TO: Steven H. Rothstein, Esq., Special Magistrate

DATE: July 6, 2026

SUBJECT: Case Number APL26-000005: Appeal filed by the Lee County District School Board of a decision made by the Cape Coral Hearing Examiner that denied four landscape deviations for a new school at 214 NW 20th Avenue.

SHEET #
LA-1
JOB # 24-22

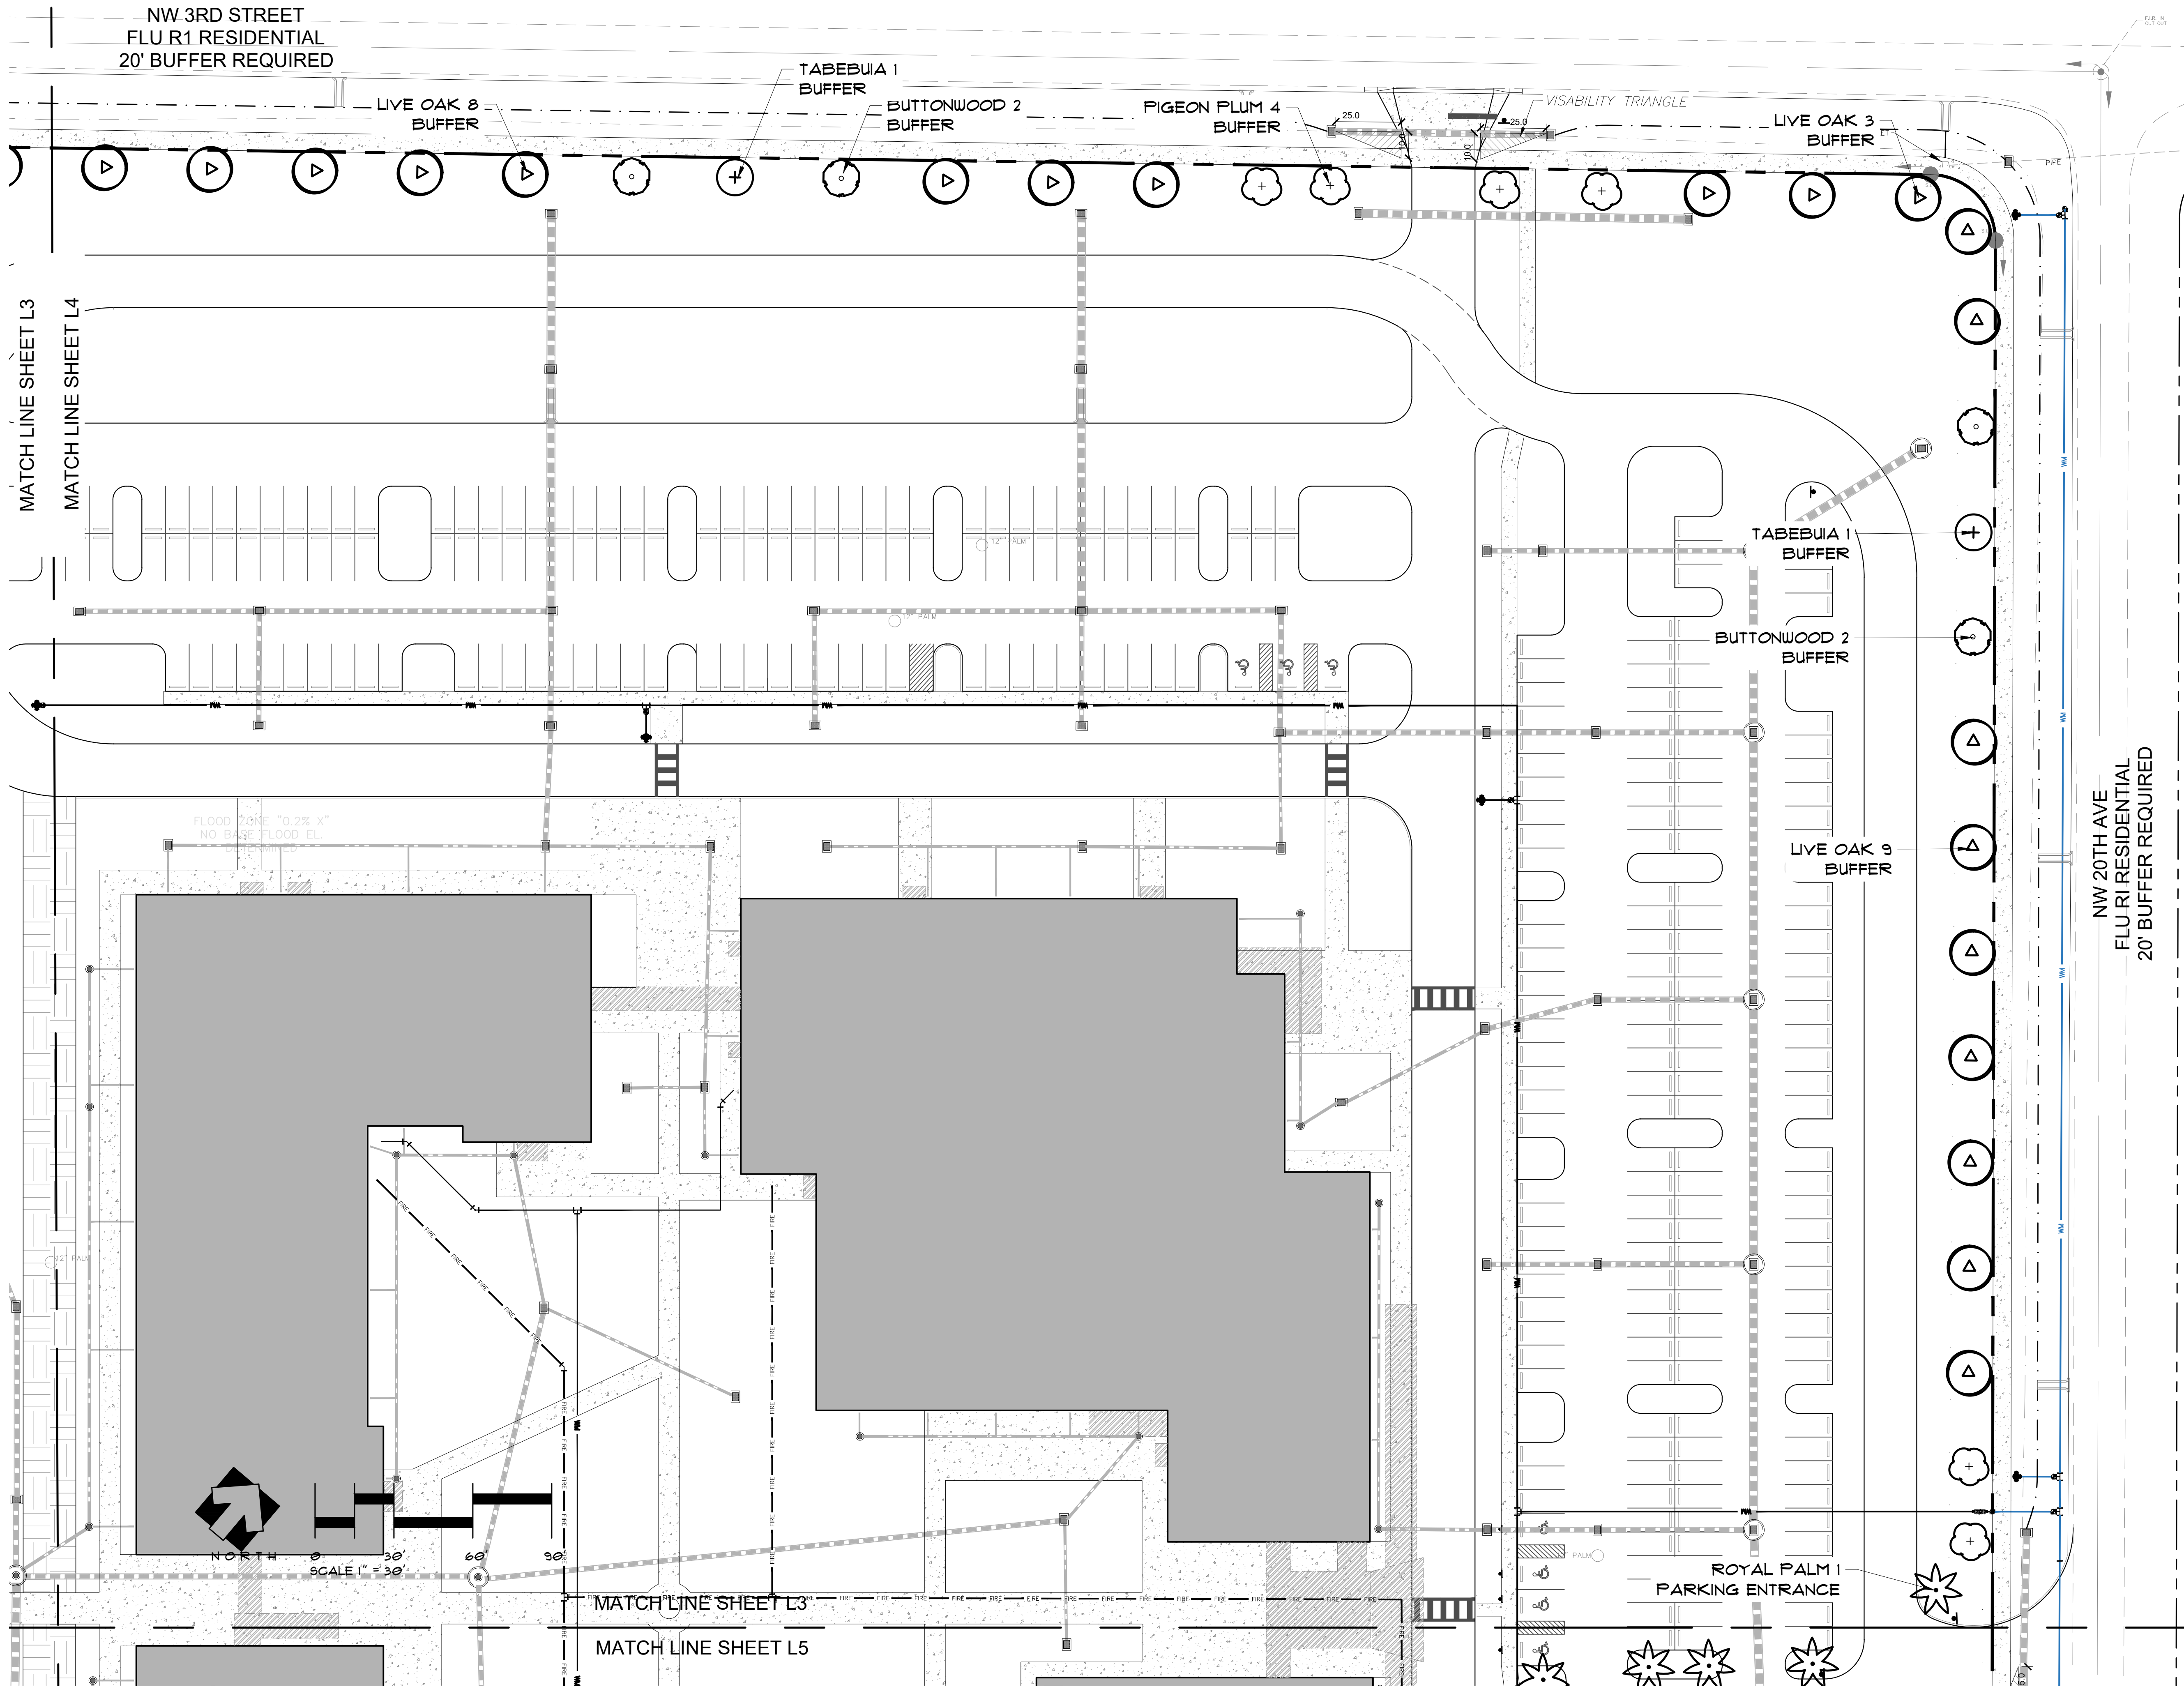
1. Do site constraints exist such as shape, topography, dimensions, and area of the property exist? ***Staff analysis and recommended findings: The area of the site is large (30.73 acres) and is rectangular in shape. The topography of the site is flat. The site lacks natural features like large bodies of water, wetlands, or rock outcrops that would inhibit the planting and growth of trees. The site also lacks overhead powerlines within perimeter easements that might otherwise restrict or limit the types of canopy trees that could be planted in buffer areas adjacent to street rights-of-way. In summary, site constraints related to both the natural as well as the built environment are absent that would prevent compliance with the landscape code regarding all four requested deviations.***

3. Are other locational factors present that make compliance with the pertinent section of the landscape code impossible or impracticable? **Staff analysis and recommended findings: The developer states that deviations sought from the landscape code are necessary to provide a safe and secure site and to improve the functionality of the site. Both issues are addressed separately below.**

In short, justifications offered by the developer in supporting the requested deviations appear to be based on general concerns or assertions and do not result from the development of a code compliant landscape plan for the site that demonstrates how school facilities or activities would be negatively affected. As the burden falls on the developer to demonstrate such a hardship, staff finds this standard has not been met for the requested deviations.

4. What effect will the requested deviation have on community appearance? *Staff analysis and recommended findings: The requested deviations will result in a substantial decrease in canopy trees on the site. About a 50% reduction in the number of canopy trees required for the perimeter buffer is proposed, while a 91% reduction to the total tree planting requirement for the site is sought. Canopy trees required for off-street and vehicle use areas are absent from the landscaping plans. The landscape plans are also devoid of shrubs. The LDC requires shrubs for foundation landscaping and buffer yards. The minimum number of shrubs alone for complying with the landscape buffer requirements exceeds 3,000 plantings. Given the number of deviations sought coupled with the magnitude of these requests, all four deviations will have a negative effect on community appearance by contributing to a site that is largely devoid of landscaping. The lack of landscaping will be particularly noticeable given the area of the site, the large footprint and height of the school buildings, and the amount of street frontage.*
